U.S. Department of the Interior BUREAU OF LAND MANAGEMENT Sundry Print Reports

Well Name: CORRAL 16-4 STATE FED Well Location: T25S / R29E / SEC 16 / County or Parish/State:

Type of Submission: Notice of Intent

Type of Action: APD Change

WELL LOCATION AND ACREAGE DEDICATION PLAT

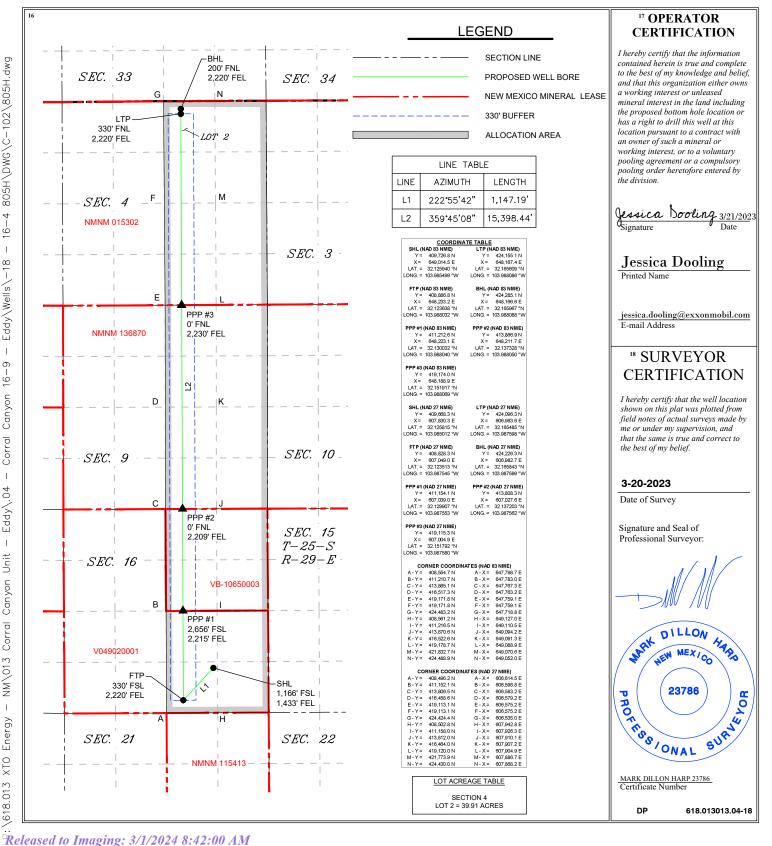
Procedure Description: ** Name Change, Pool, First and Last Take Point Changes, Bottomhole Location Change XTO Energy LLC requests permission to make the following changes to the original APD: No Additional Surface Disturbance Change Well Name from Corral Canyon 16-4 State Fed Com to Corral 16-4 State Fed Com Change Pool from 96217 Willow Lake; Bone Spring, Southeast to 98220 Purple Sage; Wolfcamp SHL: No Change Change FTP: fr/100'FSL & 1430'FEL to 330'FSL & 2220'FEL, V049020001 (State Lease, No Lease Change) PPP1(WB002): fr/: 100'FSL & 1430'FEL to 2656' FNL & 2215' FEL, VB-10650003 (State Lease, No Lease Change) PPP2(WB003): fr/: 100'FSL & 1430'FEL to 0' FNL & 2209' FEL, NMNM136870 (No Lease Change) PPP3(WB004): fr/100' FSL & 1430' FEL to 0' FNL & 2230' FEL, NMNM015302 (No Lease Change) Change LTP: fr/100'FNL & 1430'FEL to 330'FNL & 2220'FEL, NMNM015302 (No Lease Change) Change BHL: fr/50'FNL & 1430'FEL to 200'FNL & 2220'FEL, NMNM015302 Section 4-T25S-R29E (No Lease Change) Casing/Cement design per the attached drilling program. Attachments: C102 Drilling Program Directional Plan
